# PERMIT TO INSTALL PLUMBING

# APPLICATION FOR PERMIT

AP-105 Summit Street

AP - 91-115 Summit Street

WORK	PURDOST	
MANAGER	Mrs. <del>XXXXXXXXXX</del> <del>XXXXXXXXXX</del>	
SCALE	1/2" = 1 ft.	
DATE	10/21/54	
PROPERTY OF	H. T. FOX CO., INC.	
PORTLAND, MAINE	REVISIONS SHEET NO.	5

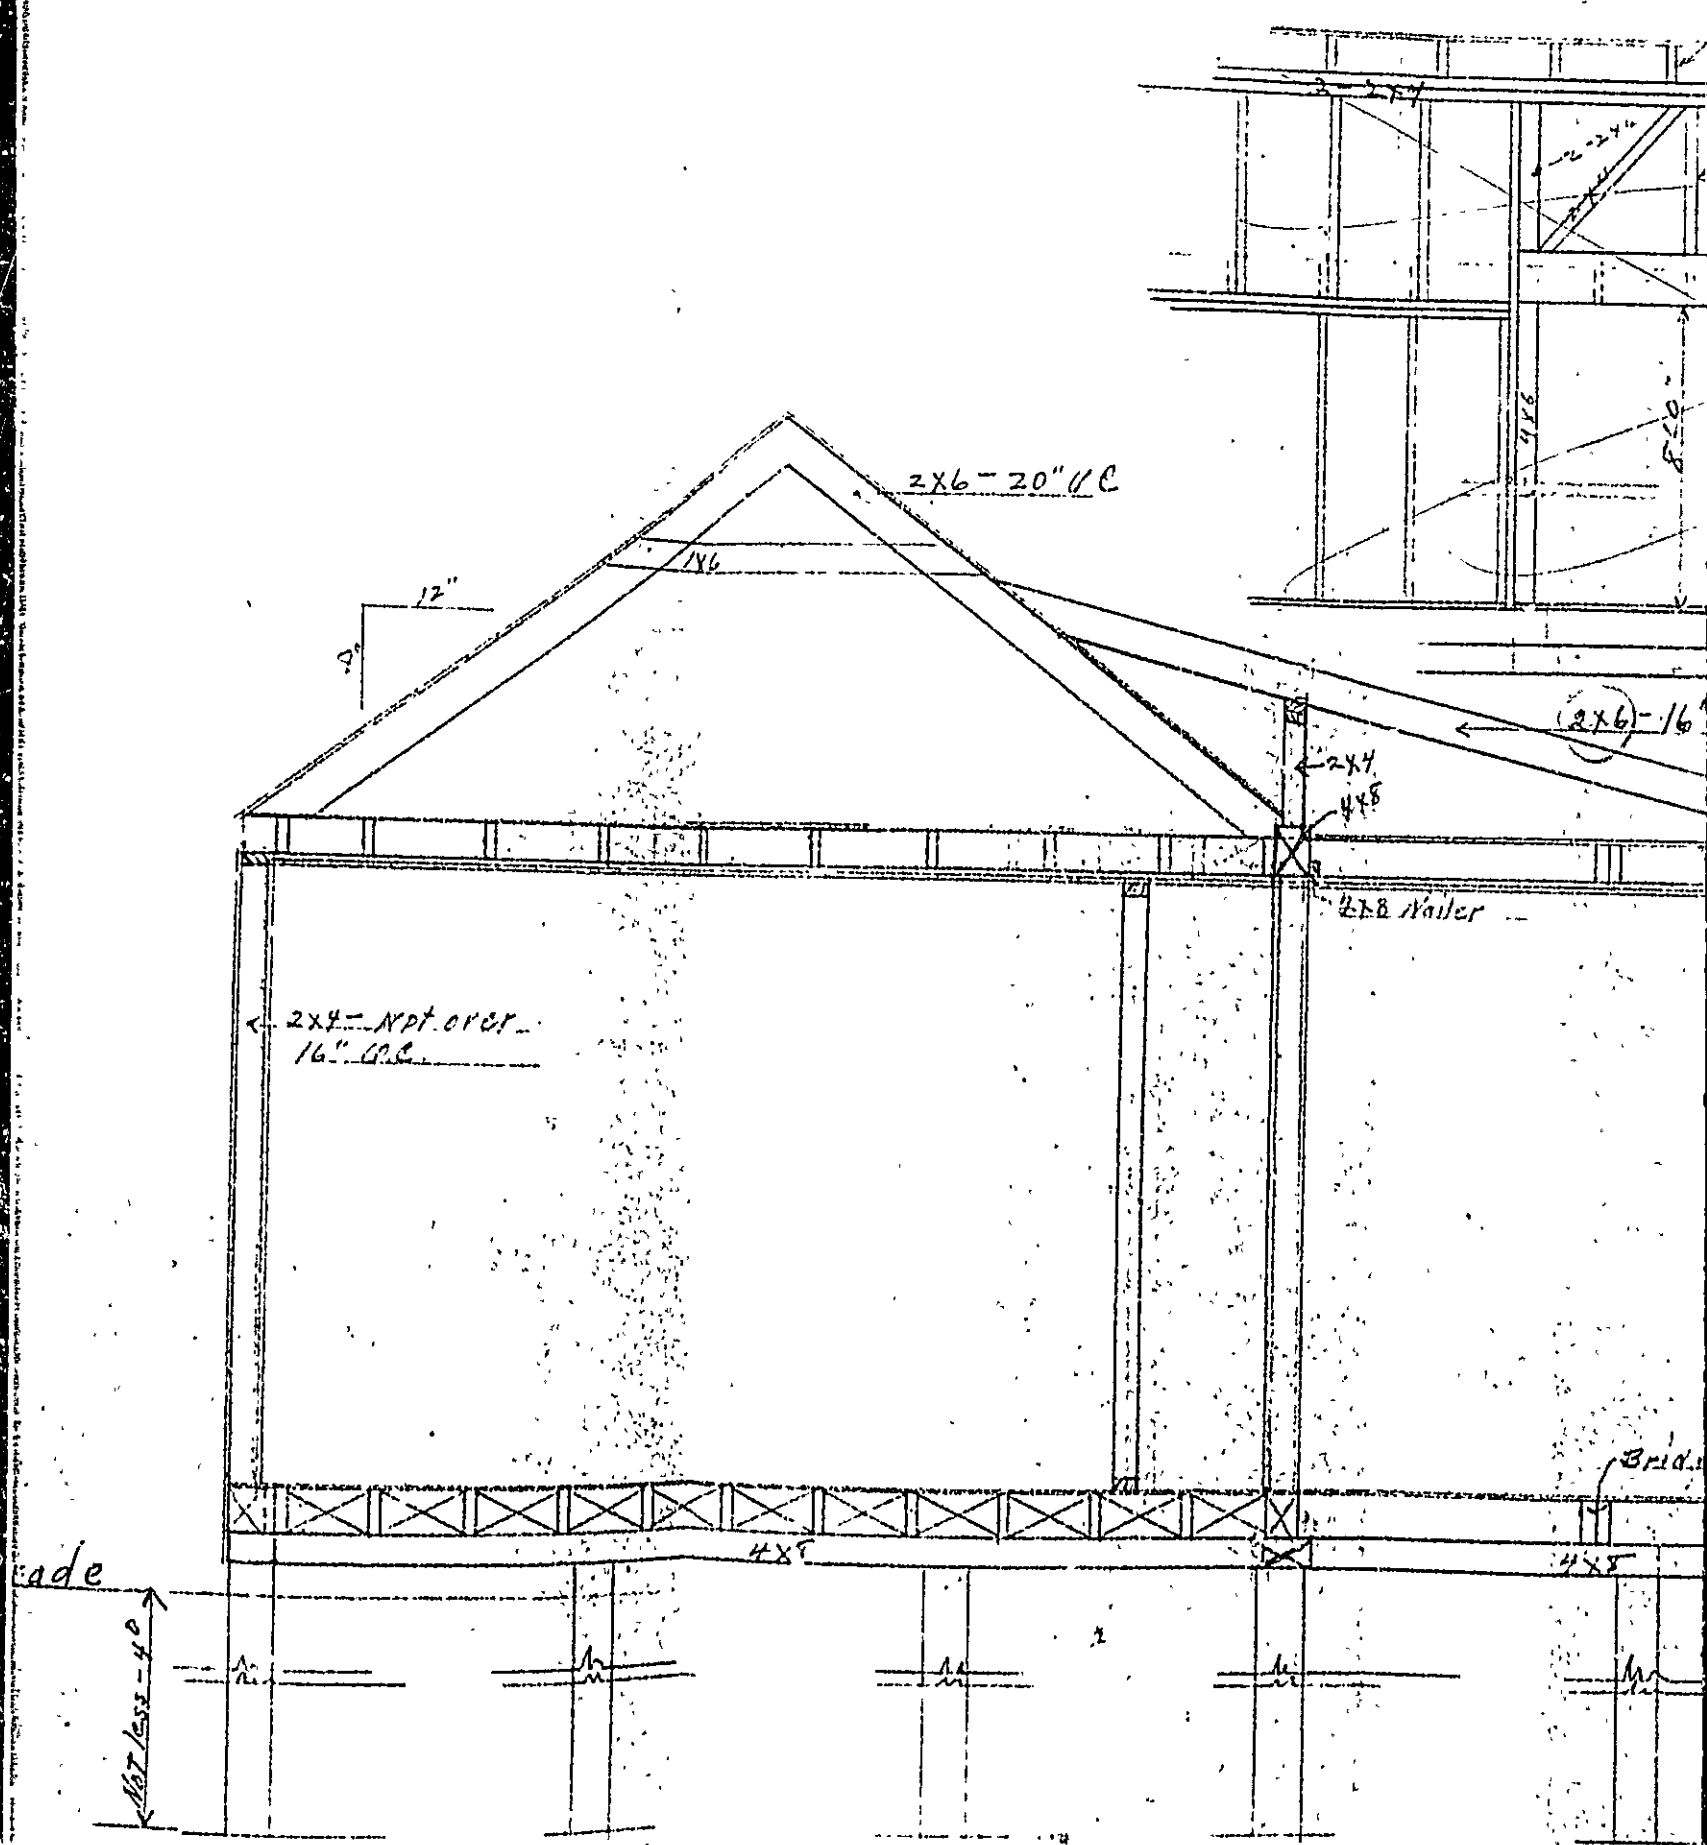
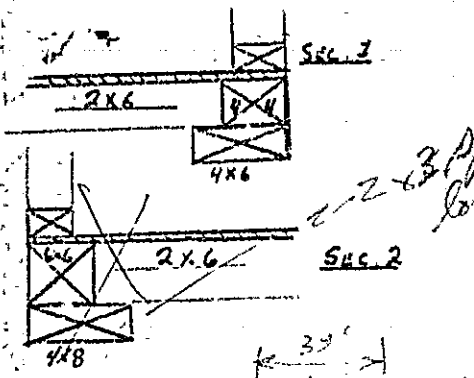
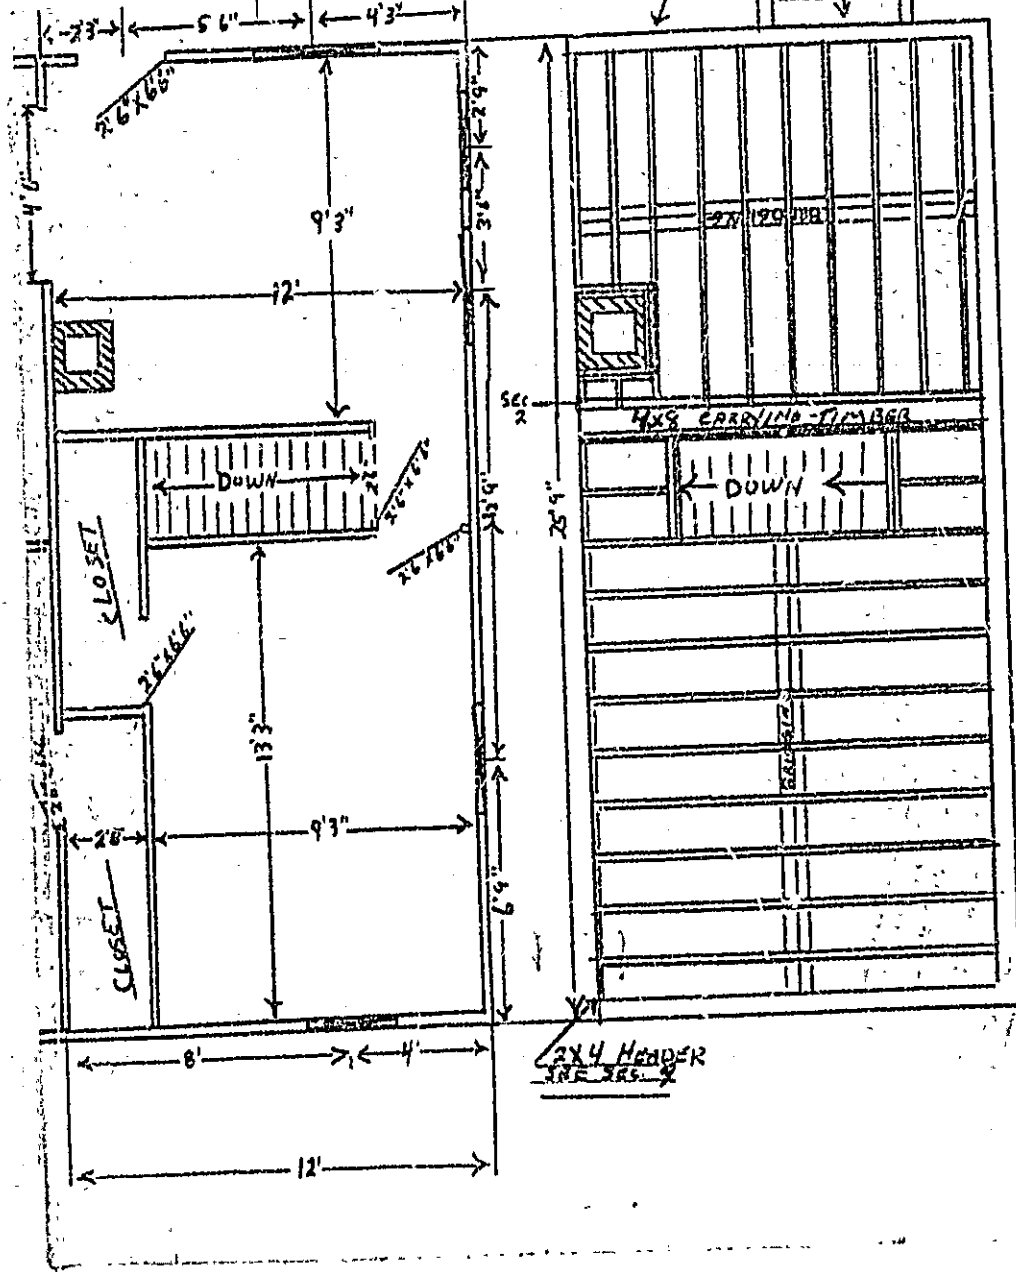
1. In accordance with the Code, the footing under the 12 inch block wall shall be a minimum size of 8 inches deep and 15 inches wide.
- ✓ 2. The carrying timber supporting a floor load and partition load at stairwell will need to be 4 inches by 10 inches.
- ✓ 3. If the floor timbers do not bear directly on the sill as shown in the sections then the joists shall be supported on a wooden strip no less than 2 inches by three 3 inches, nominal dimension, spiked or bolted to the wood sill.
- ✓ 4. Two by eight inch rafters will be required for a roof of this pitch and span.

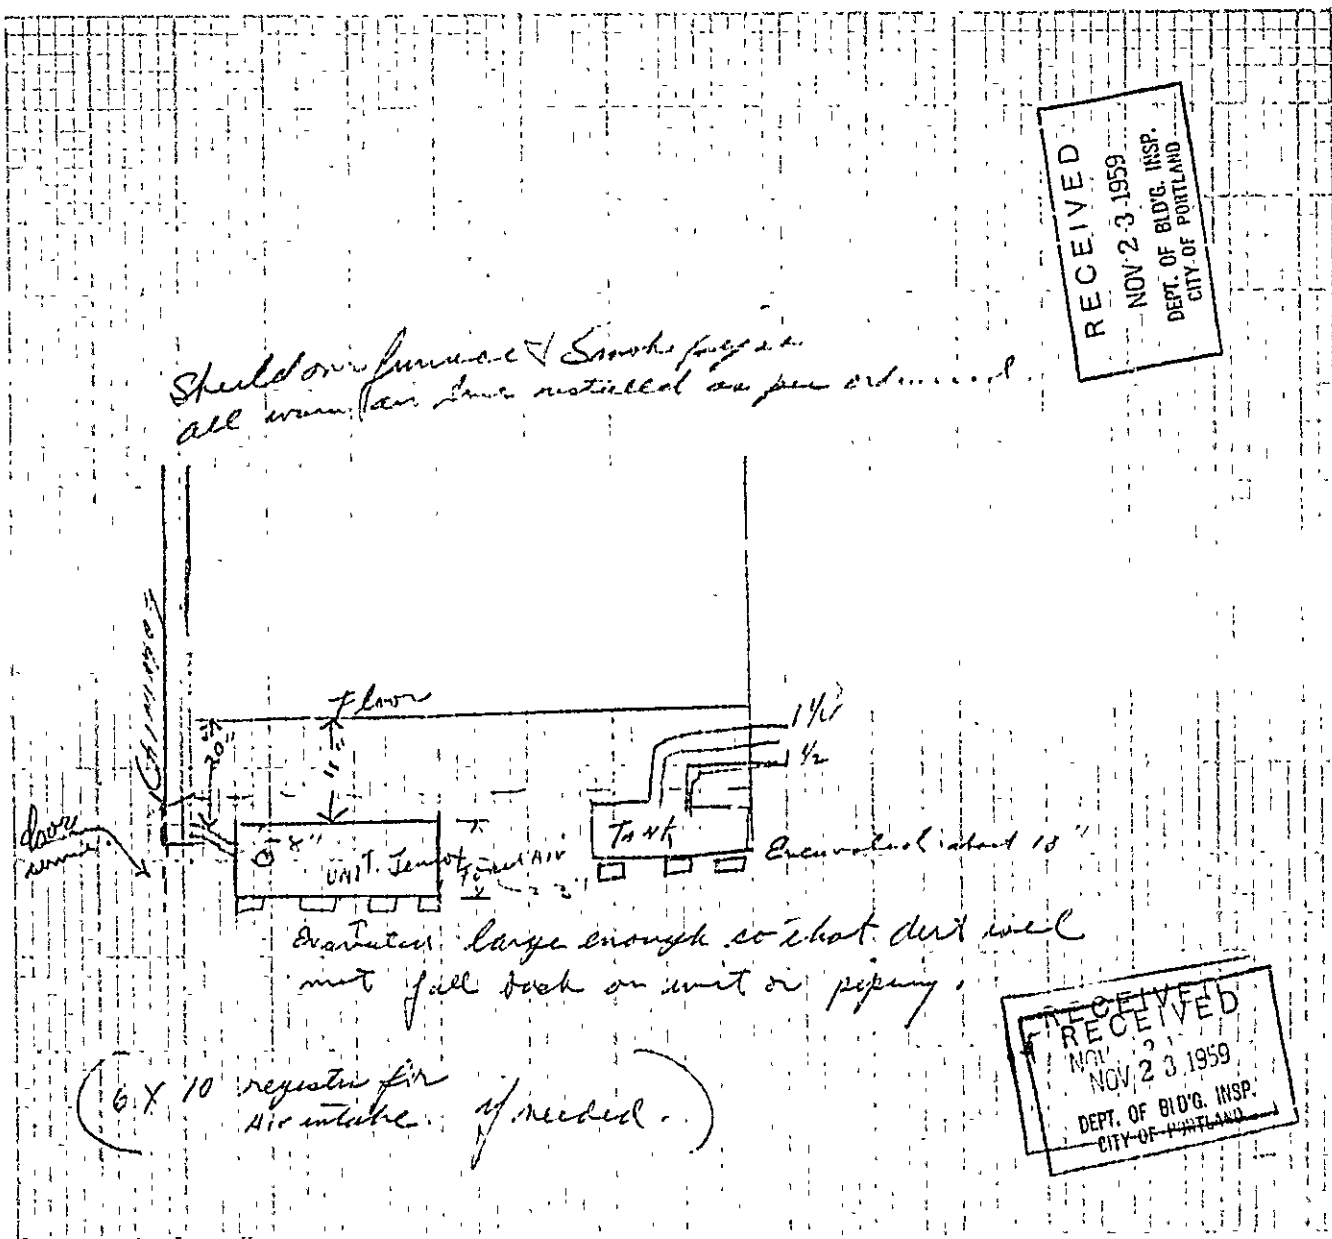
Shield over furnace & Smoke pipes  
 all warm air lines installed as per ordinance.

Exhauster large enough so that dirt will  
 not fall back on unit or piping.

(6 x 10 registers for  
 air intake if needed.)
